Notice of Decision

Land Division (Tentative Partition Plat) and Site Plan Review for Tree Felling

PA-03-24 / SP-06-24

MORENO JACKSON ST PARTITION
 2336 JACKSON ST.
 ALBANY, OREGON

Sheet **C101**
 SCALE: SEE BARSCALE

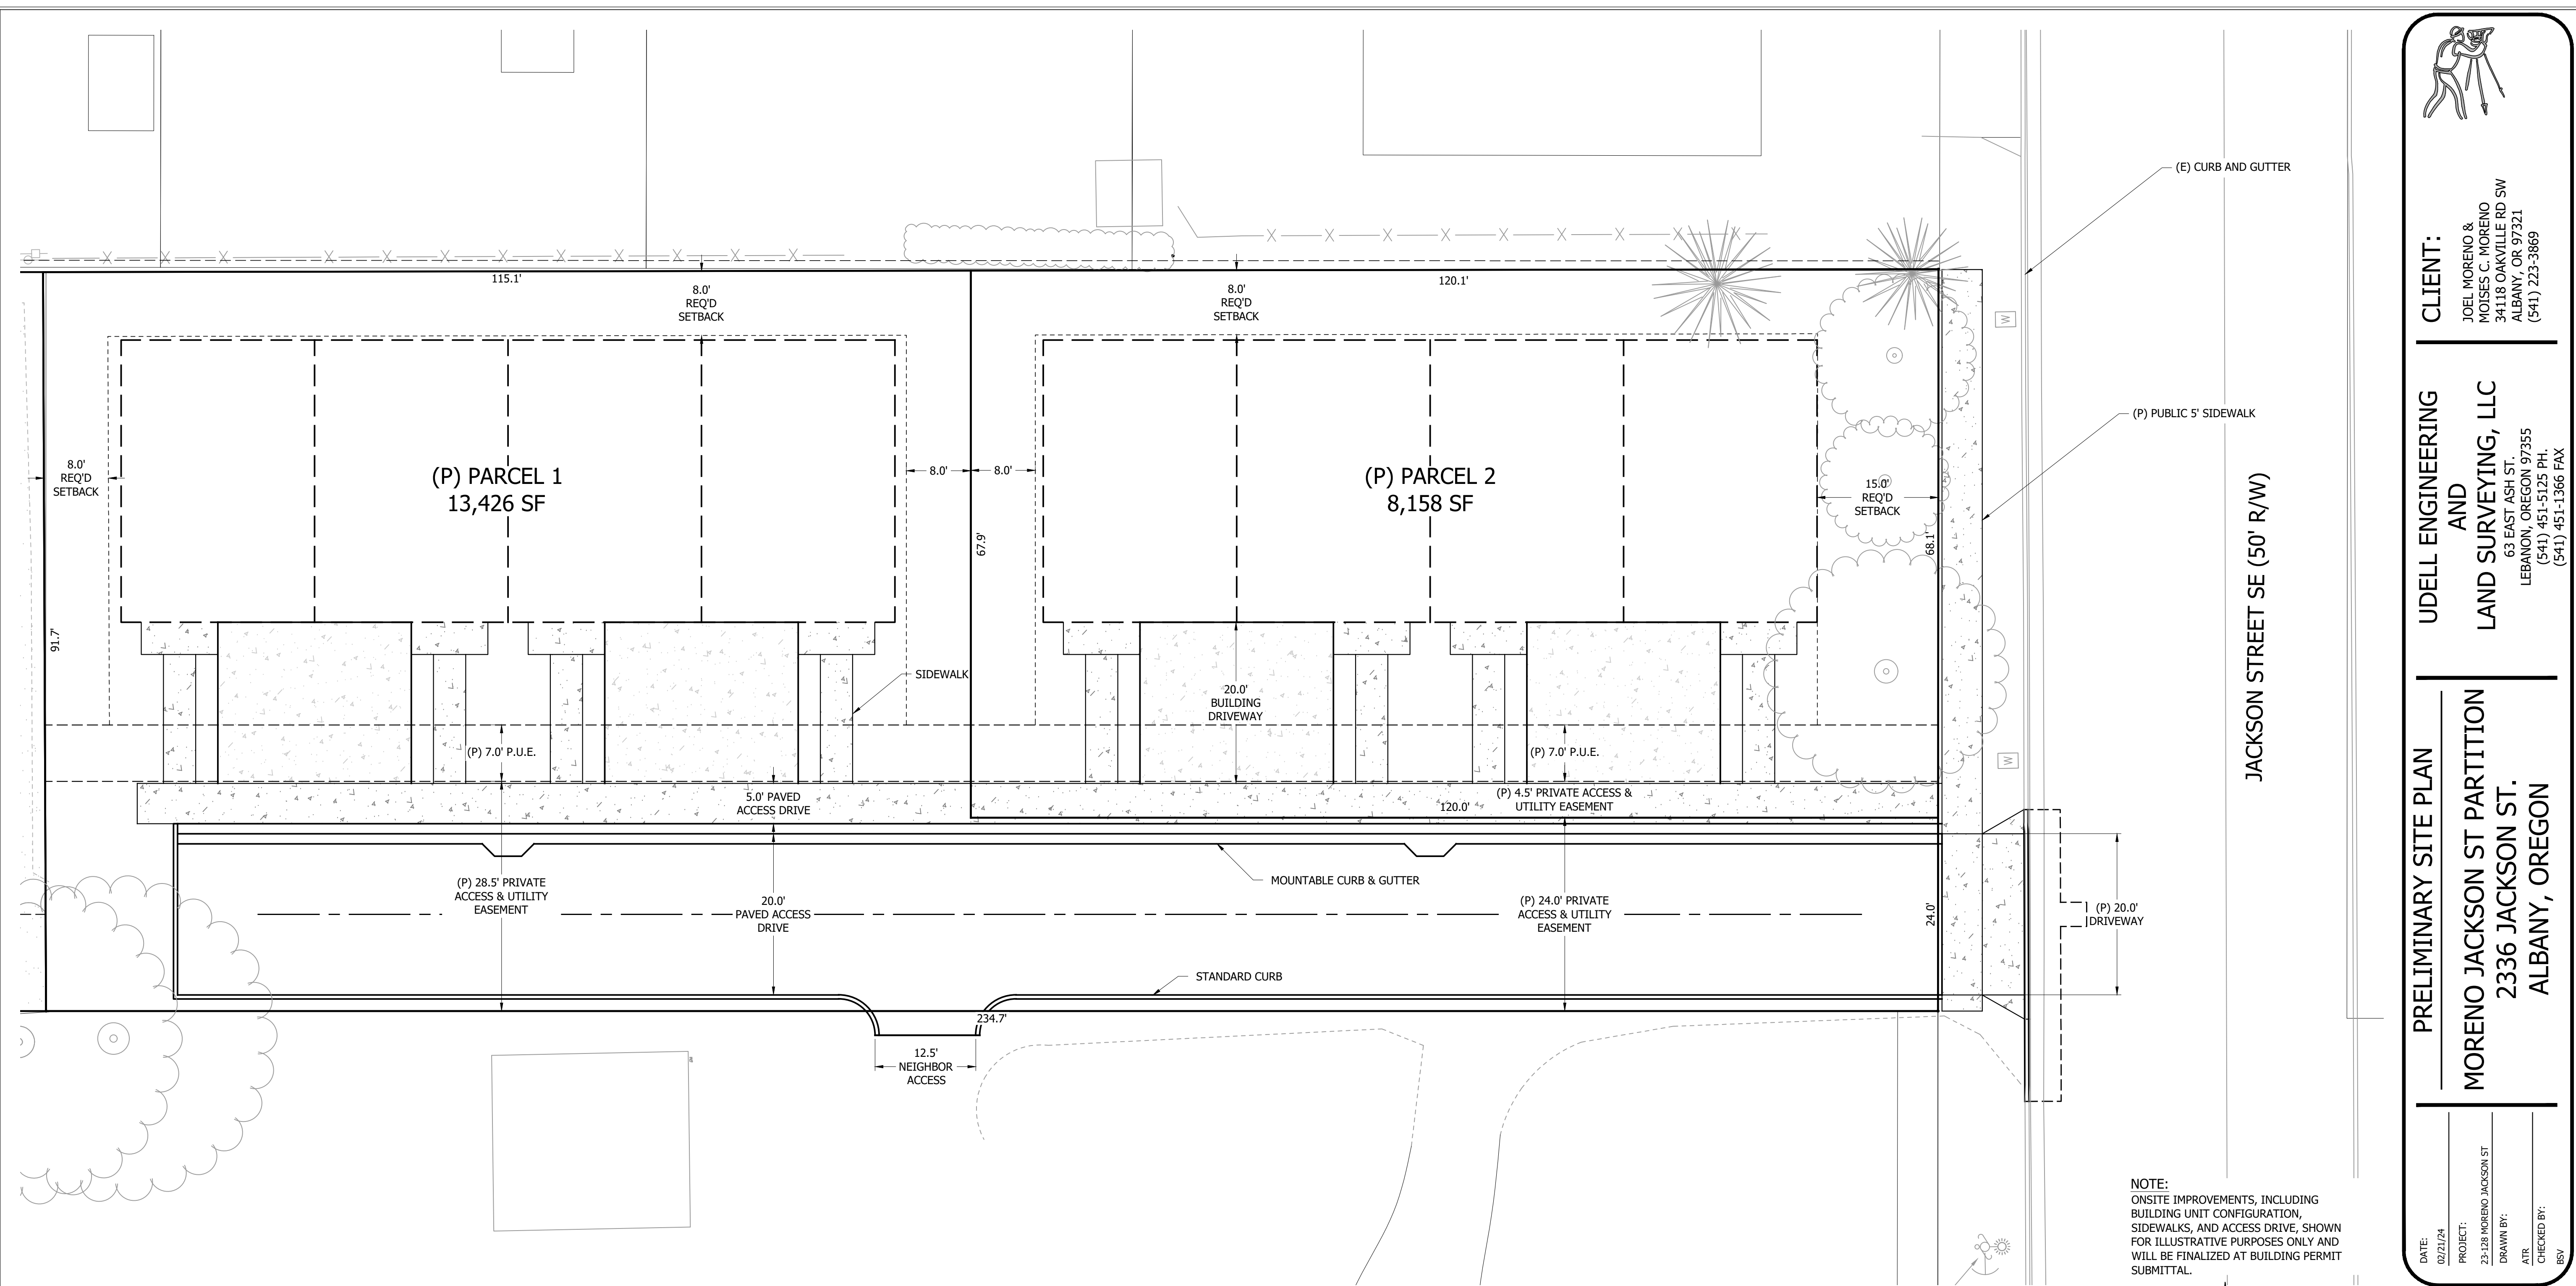
- Condition 6** In the event the proposed development does not take place, the identified for removal on the Existing Conditions Plan (Attachment B.1) shall not be removed without separate approval for tree felling not associated with development, using criteria listed in ADC 9.205(3).
